## MCGUIRE NUCLEAR STATION, UNIT 1

# AMENDMENT TO FACILITY OPERATING LICENSE

Amendment No. 115 License No. NPF-9

# ATTACHMENT TO LICENSE AMENDMENT NO. 115

FIGURE 3.4-2

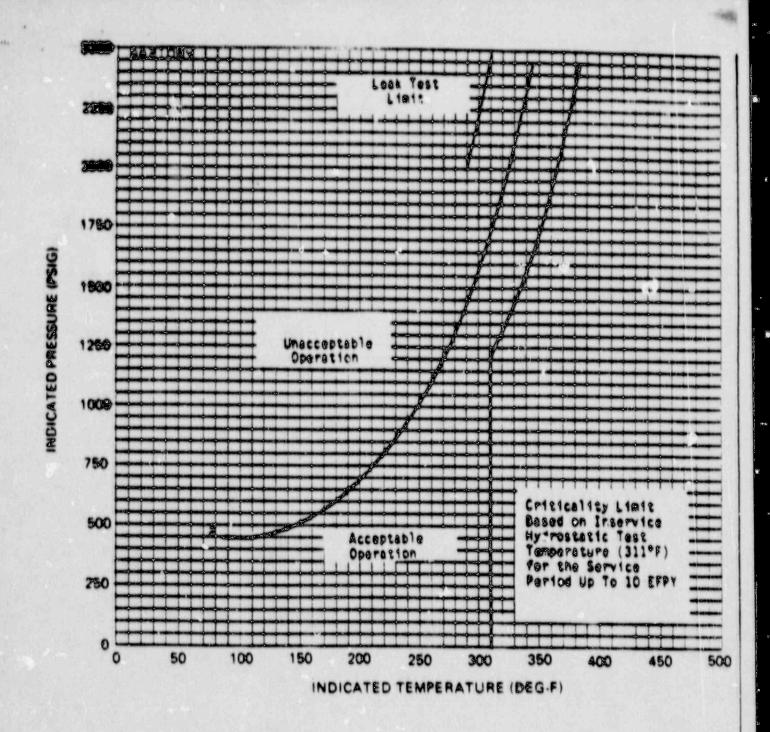
CUNVE APPLICABLE FOR HEATUP RATES UP TO 68°P/NE FOR THE SERVICE PERIOD UP TO 10 SPFY. CONTAINS MARGINS OF 18°P ARD 60 PCIS FOR POSSIBLE INSTRUMENT SERORS. MATERIAL BASIS
CONTROLLING MATERIAL - LONGITUDINAL
COPPER CONTENT: 0.21 w/8 WELD
RTNOT NITIAL: -80°P
RTNOTAFTER 10 EPPY: 1/47,165.6°P
3/47,113°P

FIGURE 3.4.3

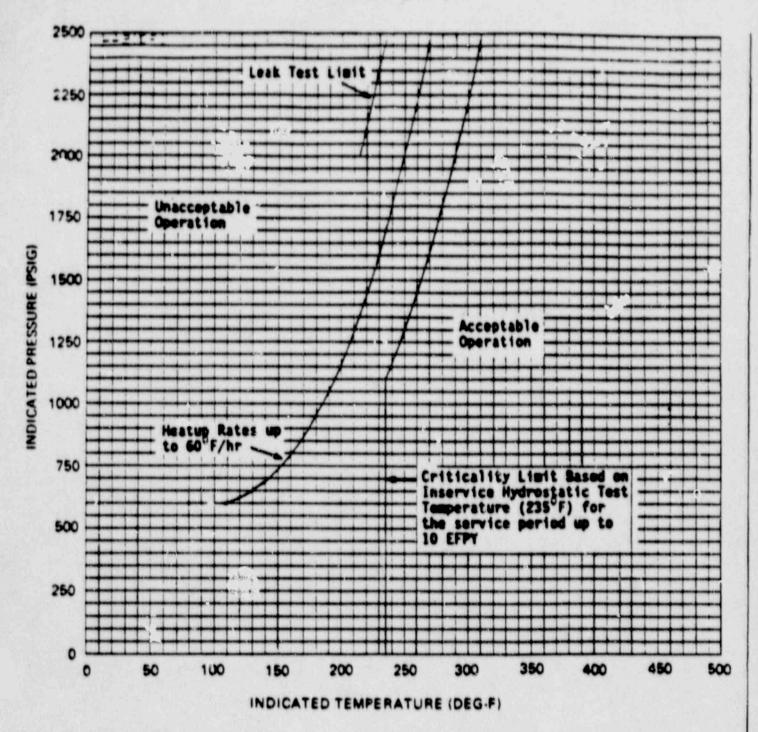
CURVES APPLICABLE FOR HEATUP RATES UP TO 60°P/HR POR THE SERVICE PERIOD UP TO 10 EPPY. CONTAINS MARGINS OF 10°P AND 60 PSIG POR POSSIBLE INSTRUMENT ERROR.

MATERIAL BABIS
CONTROLLING MATERIAL: LOWER SHELL
COPPER CONTENT: 0.18-1%
RTNDTINITIAL: -00°P
RTNDTAPTER 10 EPPY: 1/4T.00°P
3/4T.01°P

FIGURE 3.4-4 MFGUIRE UNIT 1, REACTOR COOLANT SYSTEM, COOLDOWN LIMITATIONS NRC RG 1.50 REV 2 APPLICABLE FOR THE FIRST 10 EFPY

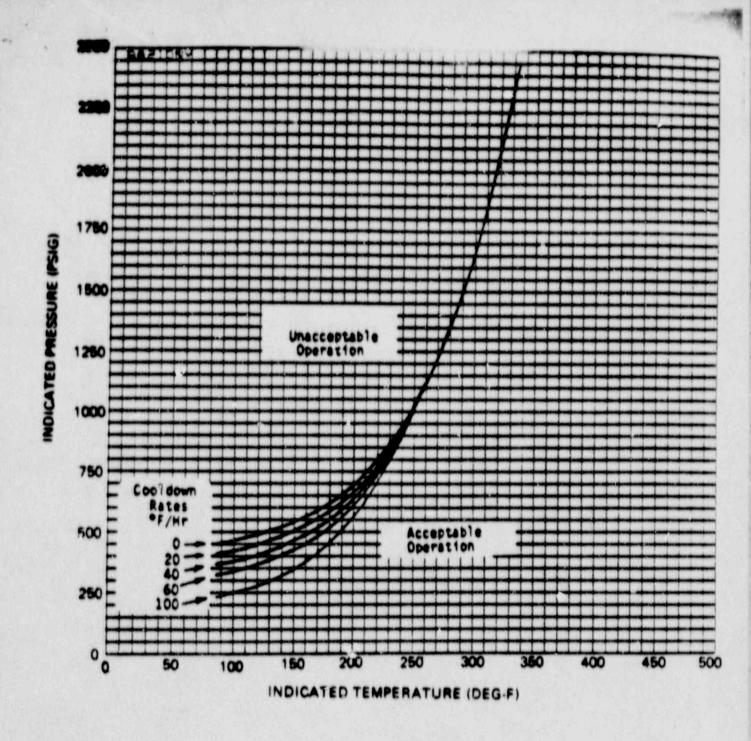
CURVE APPLICABLE FOR COOLDOWN RATES UP TO 100°P/HR FOR THE SERVICE PERIOD UP TO 10 EPPY. CONTAINS MARGINS OF 10°P AND 60 PSIG FOR POSSIBLE INSTRUMENT ERROR.

MATERIAL BASIS
CONTROLLING MATERIAL - LONGITUDINAL
COPPER CONTENT: 8.21 WIS WELD
ATMOTINITIAL: -80°P
RTMOTAPTER 10EPPY: 1/47,166.8°P
3/47,113°P

FIGURE 3.4-5 MEGUIRE UNIT 2, REACTOR COOLANT SYSTEM, COOLDOWN LIMITATIONS NRC RG 1.80 REV 2 APPLICABLE FOR THE FIRST 10 EFPY

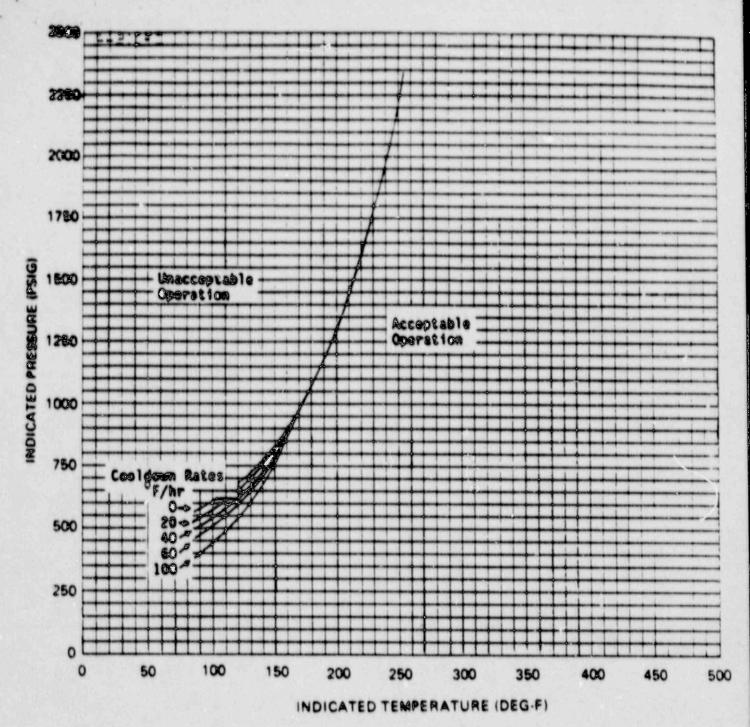
CURVES APPLICABLE FOR COOLDOWN RATES UP TO 180°PF AND FOR THE SERVICE PERIOD UP TO 18 SEPPY AND CONTAINS MARGINS OF 18°P AND 60 POSSIBLE INSTRUMENT SERVICES.

MATERIAL BASIS
CONTROLLING MATERIAL - LOWER SHELL
COPPER CONTENT: 8.16 wilk
RTMDT INITIAL: - 39°P
ATMDT APTER "O EPPY: 1/4T, 89°P
3/4T, 81°P
